From: Murphy, Mollie
To: crwispelwey@gmail.com; mossvineyards@gmail.com; candacedeloach@gmail.com
Cc: Werner, Jeffrey B
Subject: BAR # 22-12-01
Date: Wednesday, December 21, 2022 3:21:00 PM
Attachments: [image001.png](#)
[image002.png](#)

Certificate of Appropriateness Application

BAR # 22-12-01
300 Court Square, TMP 530096100
North Downtown ADC District
Owner: Eagle Tavern, LLC
Applicant: Candace DeLoach et al
Project: Exterior alterations

BAR # 22-12-01
300 Court Square, TMP 530096100
North Downtown ADC District
Owner: Eagle Tavern, LLC
Applicant: Candace DeLoach et al
Project: Exterior alterations

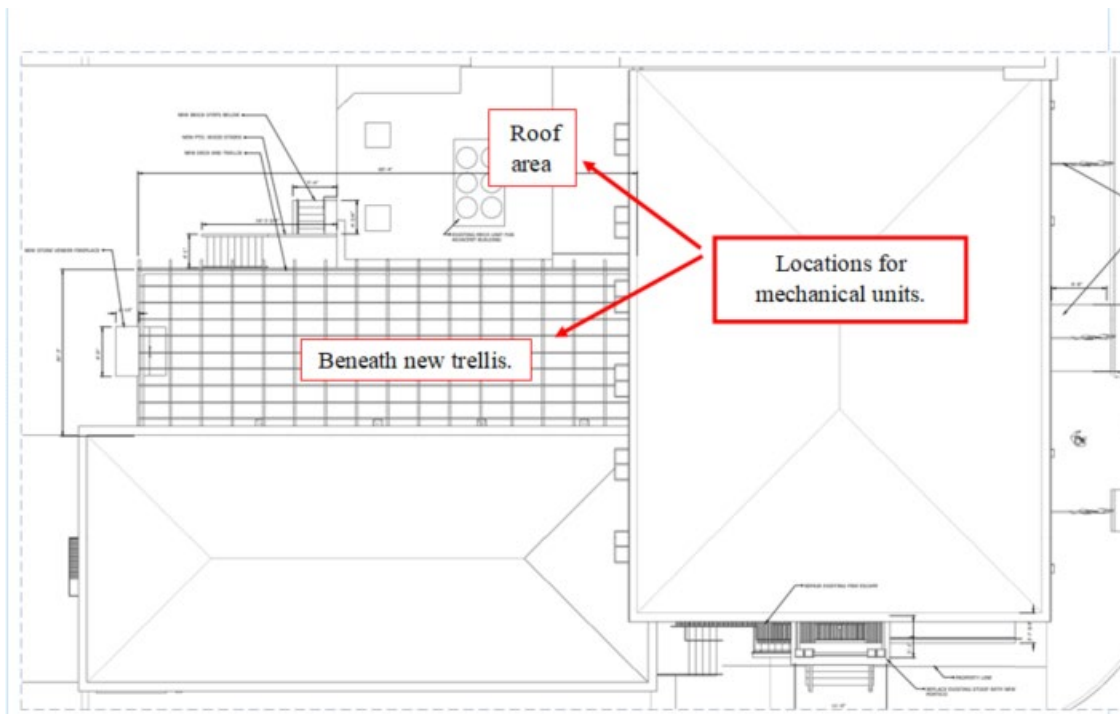
- Separate signage package. [All signage will require a separate signage permit.]
- Mechanical units will be screened. [Applicant indicated locations at the rear: Beneath the rear trellis/deck and on the low roof area. See image below for clarity.]

1 EAST ELEVATION
 A1 1/4"=1'-0"

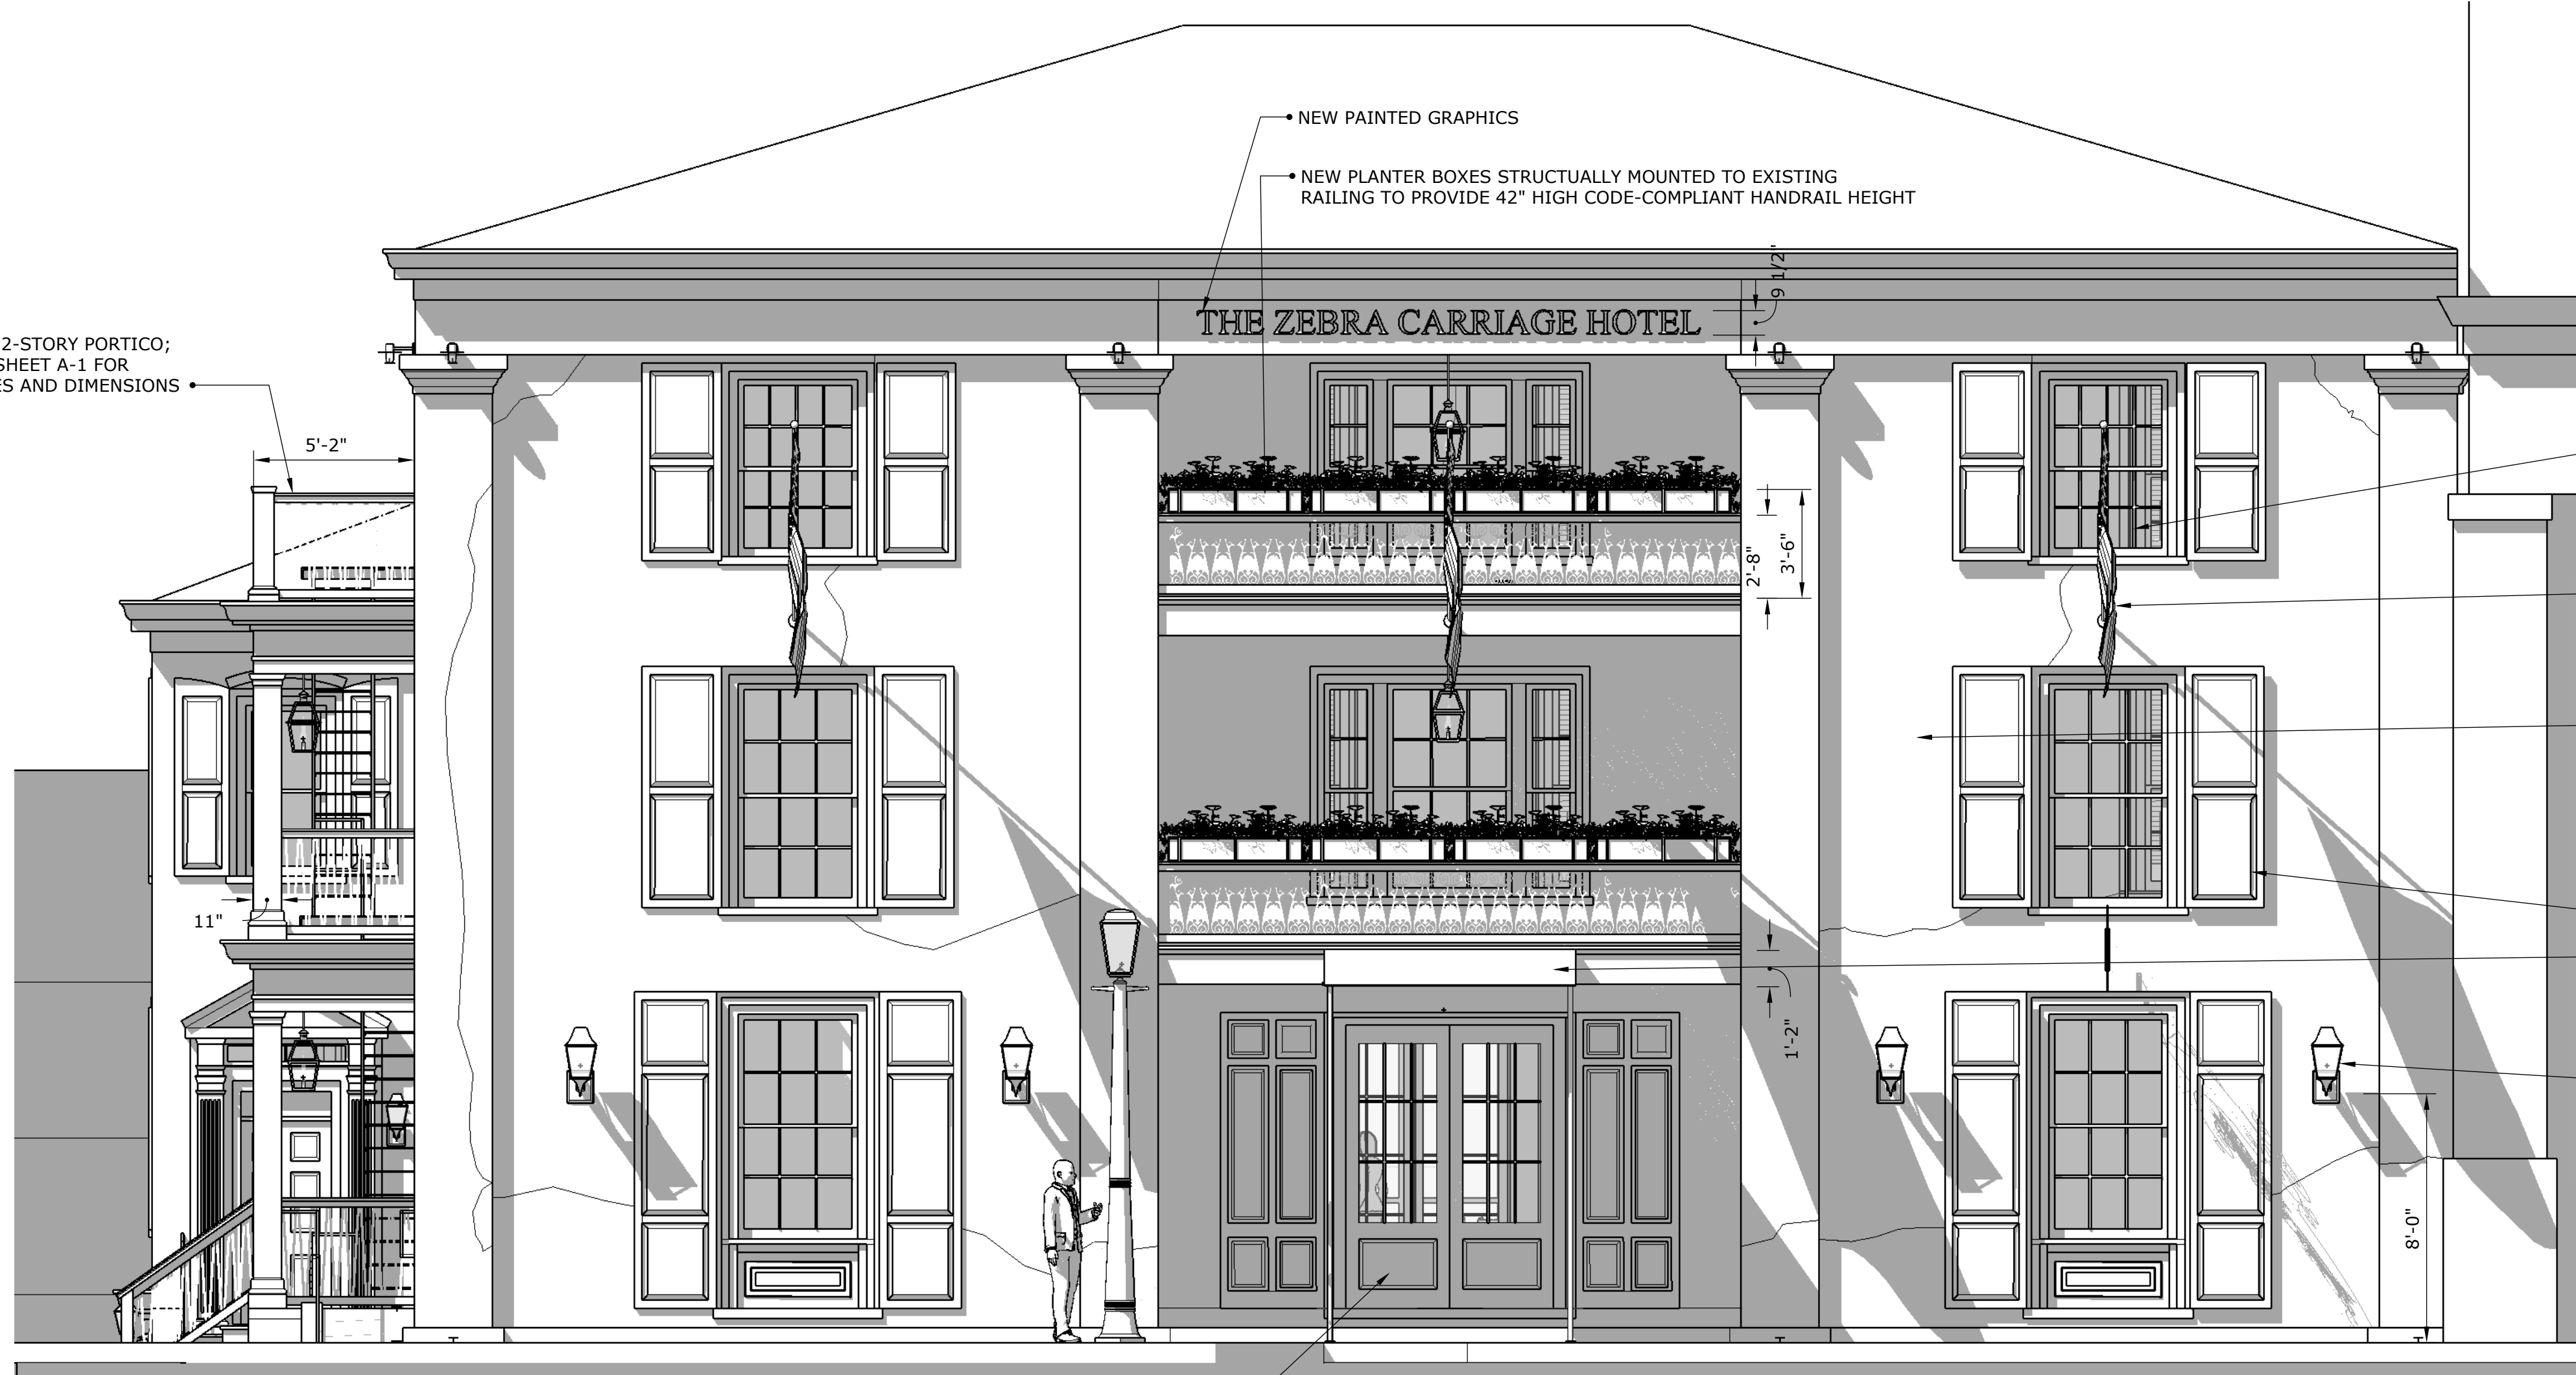
East Portico

The metal fire escape will be retained and incorporated into the portico, if constructed. Second, due to possible encroachment into the City right of way, a CoA should include a condition that construction requires resolution of any encroachment. Additionally, the CoA assumes the design will not require significant alterations due to building code requirements.

BAR should discuss the design options:

- Using available information and period examples, attempt to reasonably replicate the original. (See photos in Appendix.) BAR should discuss if [*non-historic*] upper section should mimic the lower or be distinct from it. (See also the photos included in the November submittal.)
- Treat the portico as a new element entirely and design accordingly.

- All [setback] encroachments are subject to City zoning [specifically relative to the east portico, awning at the north entrance, and any projections out into the right of way, and anything in the sidewalk].

1 NORTH ELEVATION
A2 1/4"=1'-0"

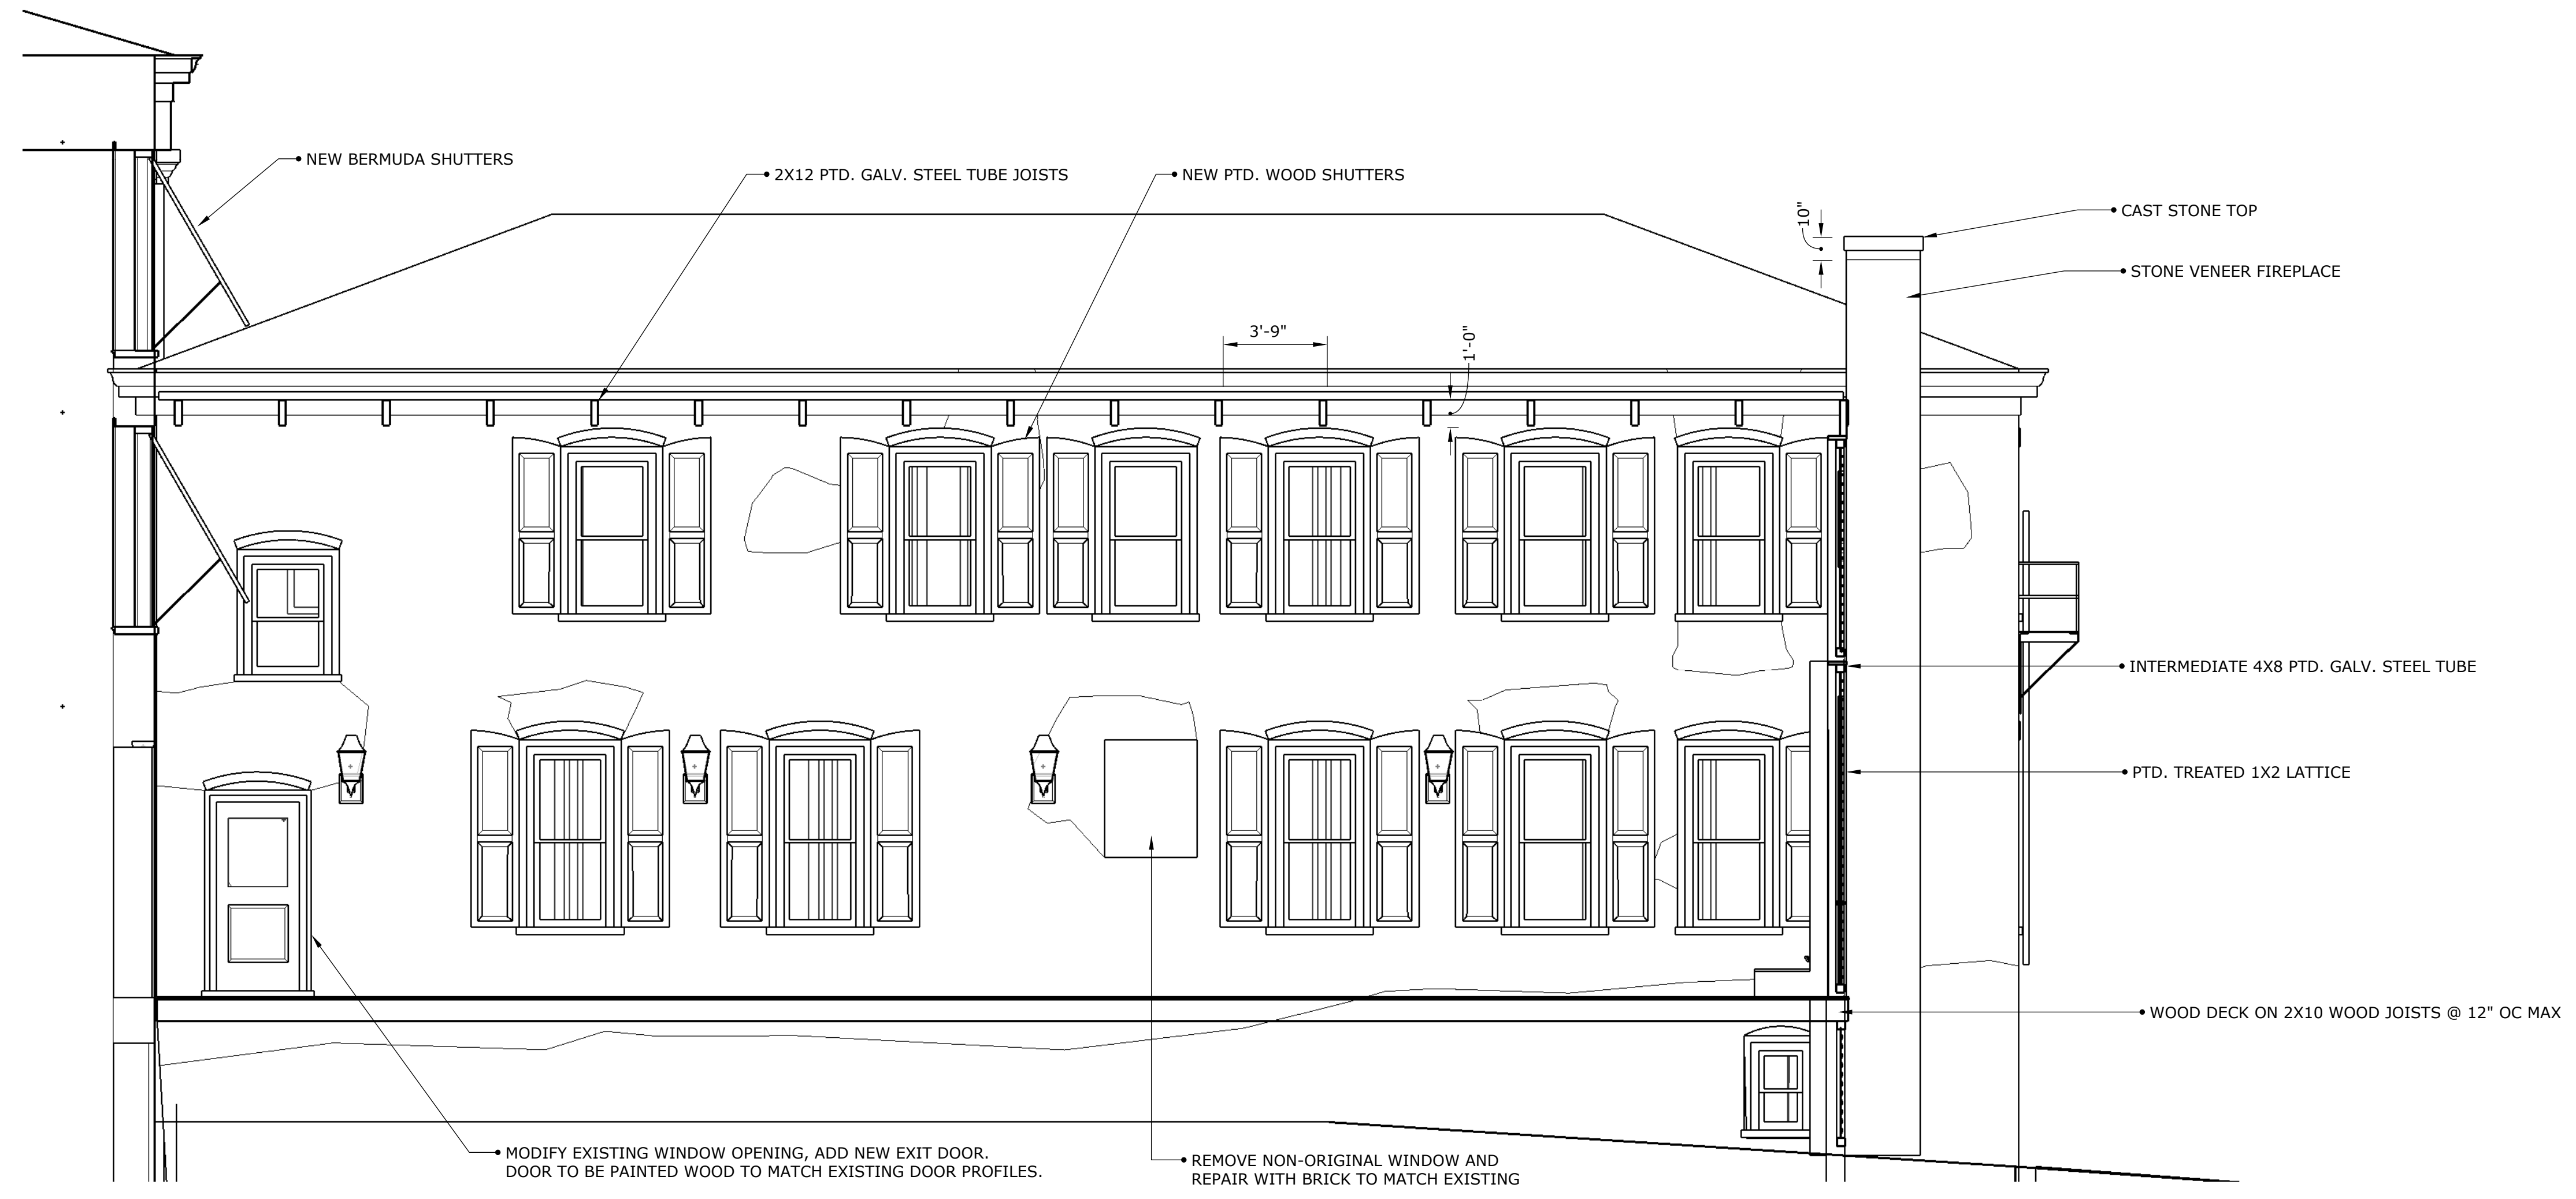
Removal of four windows, north elevation

Re removal: We cannot say when these windows were installed, only that three were there in 1915. Per the design guidelines: *Retain original windows when possible*. The Secretary’s Standards allows for *Removing windows from other historic period*, provided they are properly documented and a recommendation they be stored.

Re: infill of openings: If windows are removed, the BAR should determine how the masonry opening will be treated. (For example, if infilled with brick, should the it be toothed-in with matching bricks and coursing or in a manner that makes the infill evident?)

- For removal of the four windows [north elevation], infill the openings with brick, but have a grout line indicating where the windows used to be. Do not *tooth-in* the infill into the adjacent brick]. Infill panels to be set back ¼' to ½" [per applicant suggestion].
